THIS PLAN TO BE READ IN CONJUNCTION WITH
MOD2016/0298
NORTHERN BEACHES COUNCIL

Harbord Diggers
80 Evans Street Freshwater

SECTION 96

Courtyard Elevations - Sheet 3

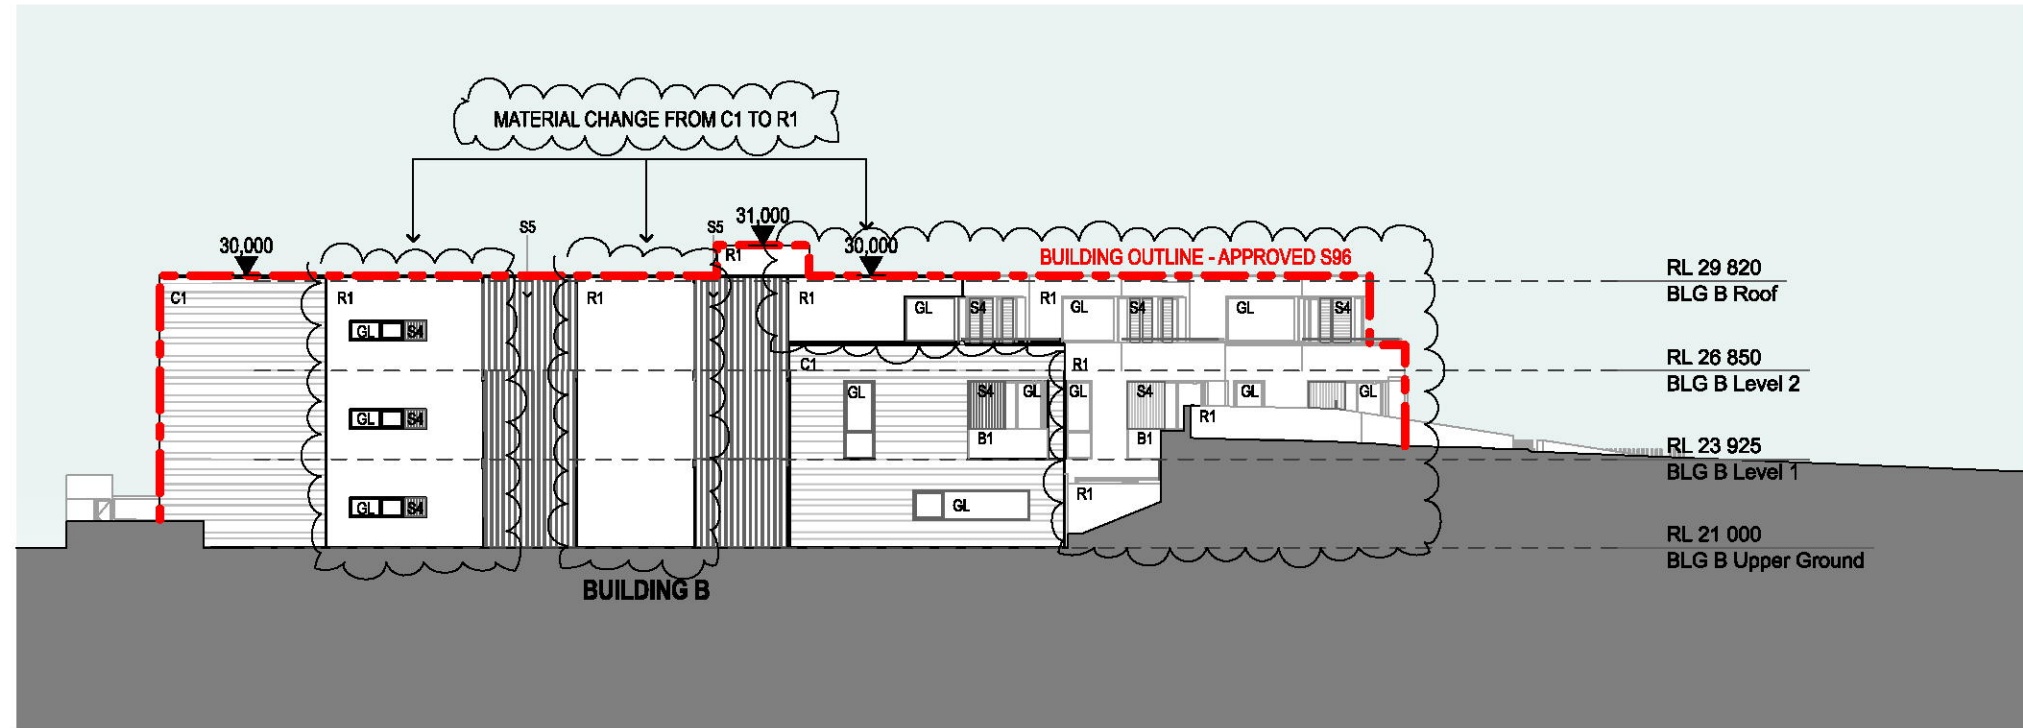
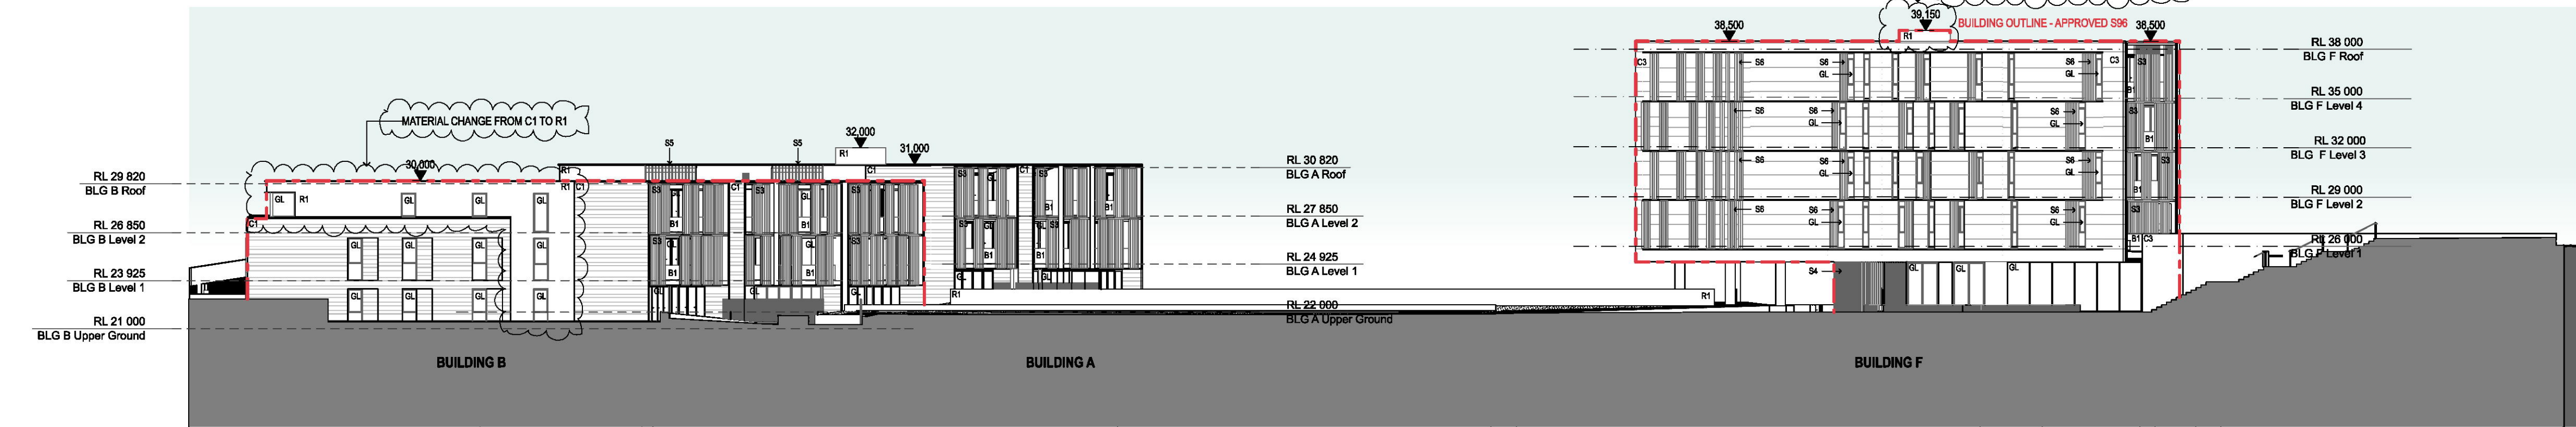
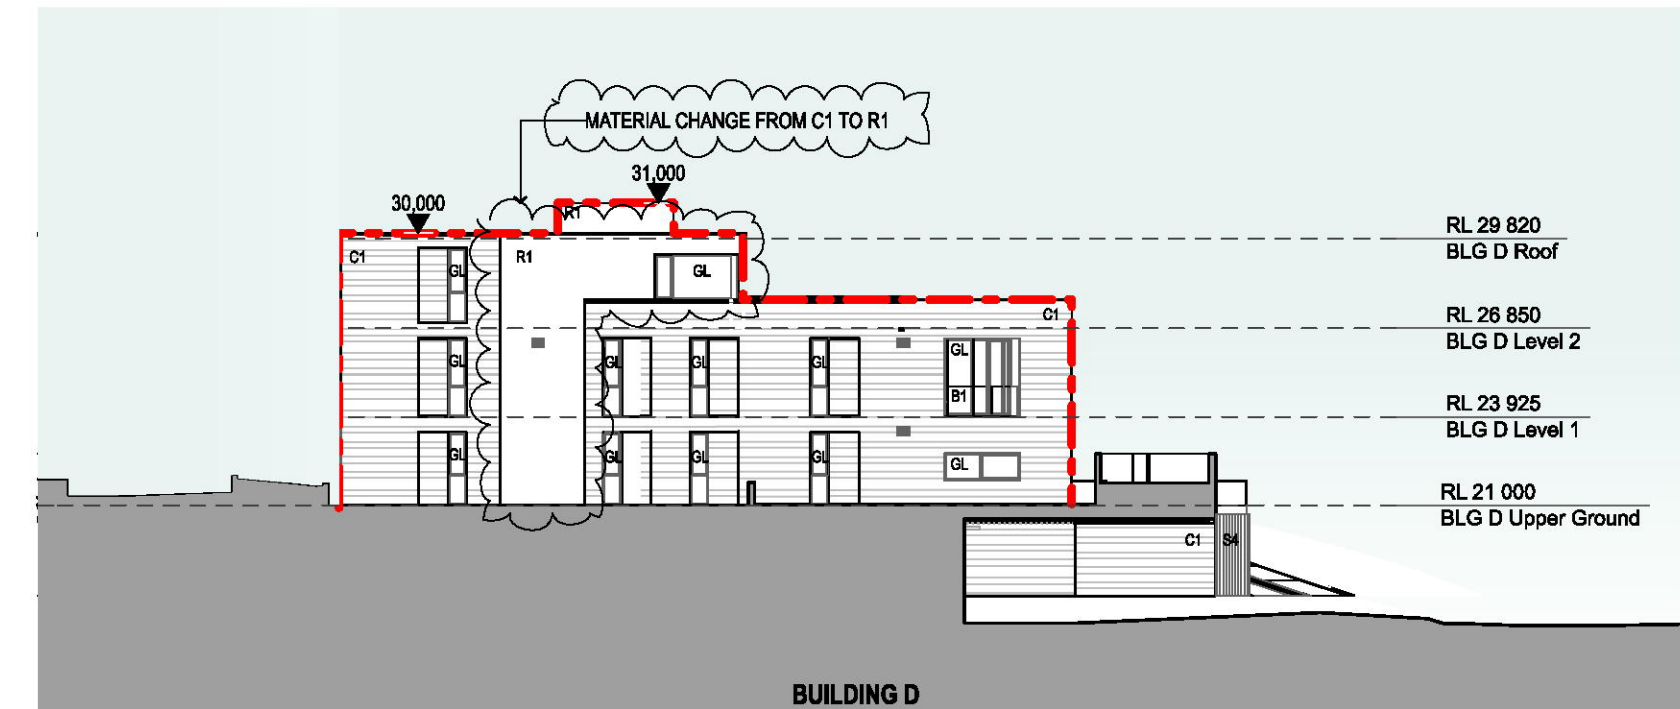
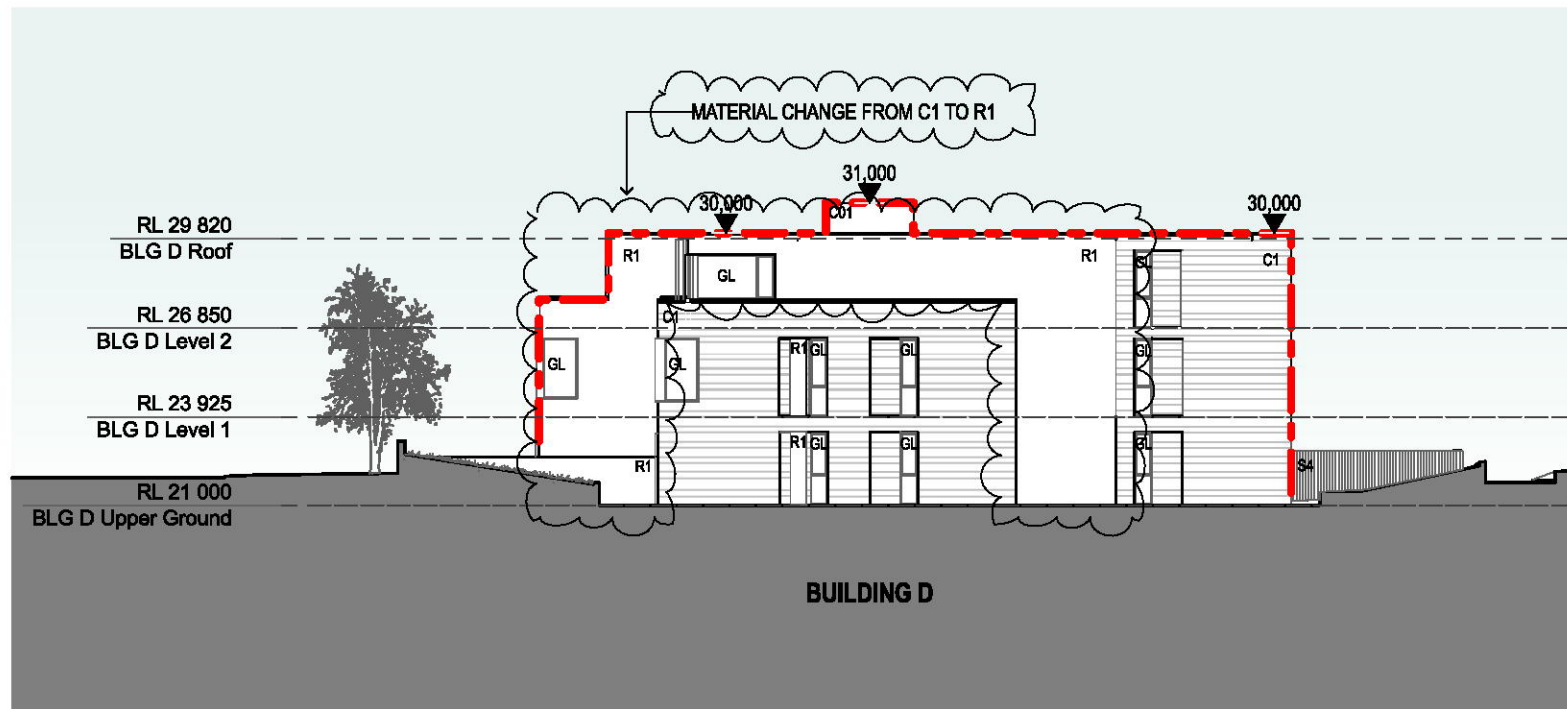
GENERAL NOTES:
- Minor adjustments to window sizing and placement
- Minor reduction in sliding screen quantities

Minor adjustment to material palette

Materials Board

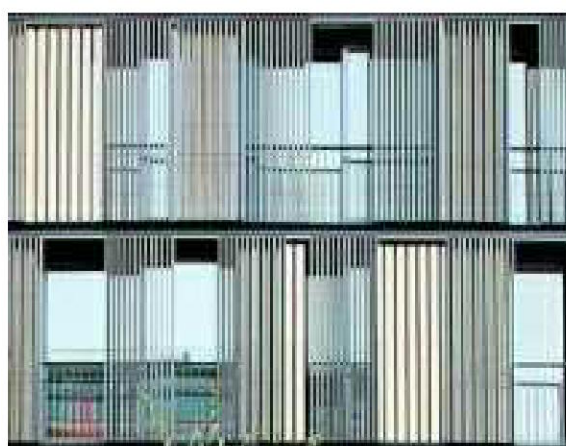
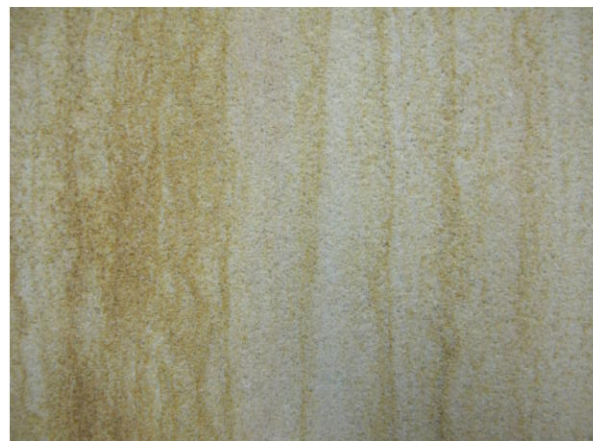
Updated sandstone colour selection

Updated fence description

Introduction of render

Introduction of additional sandstone colour

Introduction of additional screen colour
